BLUE RIVER PLANNING AND ZONING COMMISSION MEETING

A. 1253 Indiana Creek Rd – New Construction

TO: Chad Hull - Town Manager/Clerk
FROM: Kyle Parag, Plan Reviewer - CAA
DATE: July 24th 2026
RE: Planning/Zoning/Architectural Guidelines review – 1253 Indiana Creek

LOTKO STATION at SPRUCE VALLEY RANCH

A002

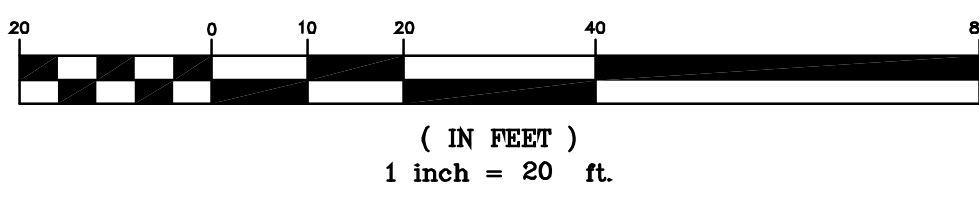
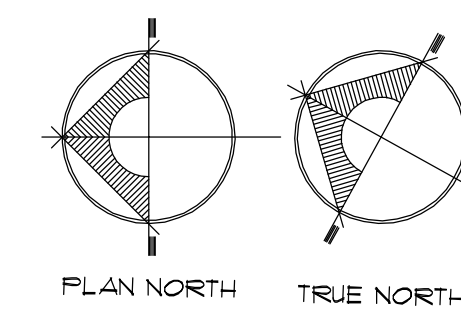
Height: Architect has provided calculations on sheet A002 that indicate the height at various locations. Architect measured from natural grade, as standard in the County. Architect indicates compliance with the 35'
However, the LUC has stricter height requirements, and requires the building to meet **either the original or final** height above grade. Since this

project involves significant excavation, there are numerous areas that appear to exceed 40' in building height.
Carriage house complies.

Following discussion, the Commission generally agreed that the proposed recessed garage entrances may qualify as basement-entry features contemplated by the Code. The Commission requested revised exhibits showing both existing and proposed grades to clearly demonstrate compliance with the 35-foot height limitation.
